## Title: Service Bulletin For 6 Cylinder SDS Equipped Engines

**Engines Affected:** H6 engines with SDS units NOT equipped with zener diodes.

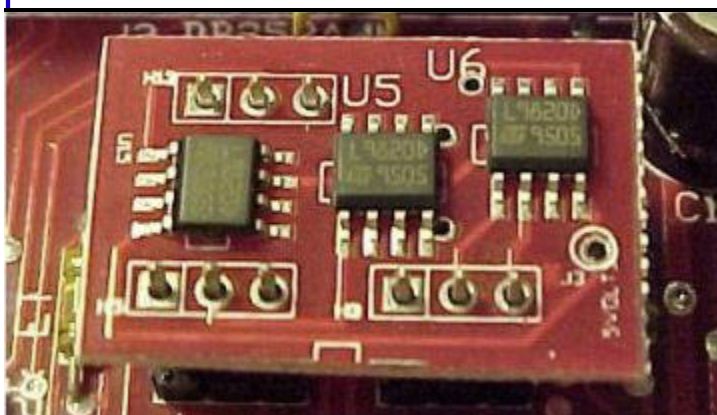
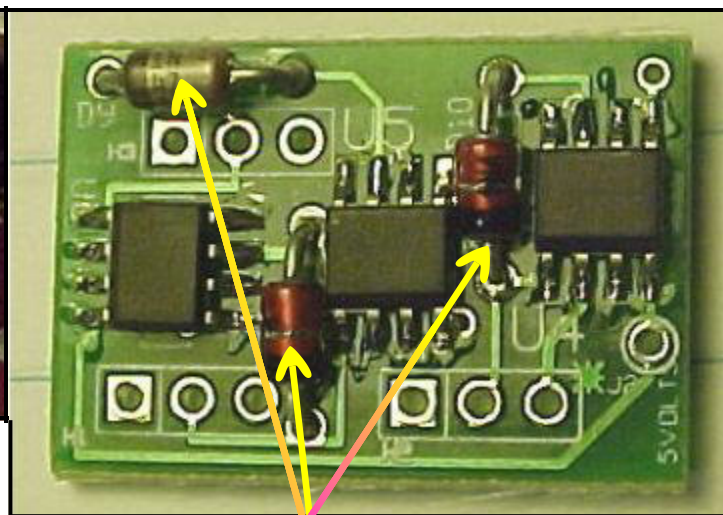
**Summary Statement:** Some SDS ECUs may have not have been sent back to Racetech Inc. for an upgrade to the coil driver circuits. This can result in one or two pairs of coils not firing on start up.

**Corrective Action:** All H6 owners should with SDS equipped ECUs should remove the lid from the ECU and look at the sub board shown in the photo. If your board does not have the 3 zener diodes (shown in right photo) soldered to the board, please return your ECU to us for the mod. We'll pay shipping both ways and do the mod at no charge. Send to:

If your SDS board looks like the above then it will need 3 zener diodes added to it. Most

have been upgraded but everyone should check their SDS ECU. Zener diodes are shown on the upgraded board to the right so you know what they look like. It seems that perhaps inductive spikes from the engine starter motor may be damaging some of the driver chips.
